Review #1

KKC18, LLC
Minor Subdivision
Application P-24-009
R-2 DETACHED/ATTACHED RESIDENTIAL DISTRICT

57-59 Evergreen Street
Block 320, Lot 10.01

April 14, 2026

Architectural Elevations of the Proposed Front Façade (right) and Side Façade (left)

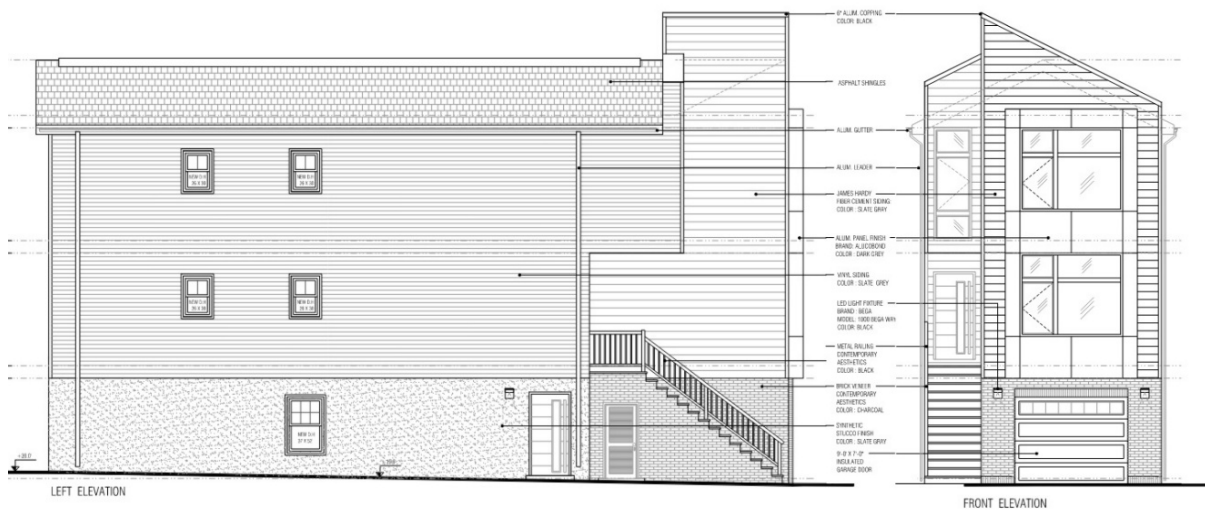
8.2. Proposed Building - Exterior. The proposed buildings are three-stories with the front of the buildings having an asymmetrical roof line and contemporary façade. Each building contains more than 3,000 sf. of living area, similar in scale to typical two-family dwellings in Bayonne. The side and rear façades have clapboard style vinyl siding on the second and third floors while the ground floor has a stucco finish. The color palette consists of shades

of gray; charcoal brick, slate gray stucco, vinyl and fiber cement clapboard siding, dark gray aluminum composite panels, and black railings. The window trim and doors are not specified. No renderings have been provided but an architectural elevation is provided below.
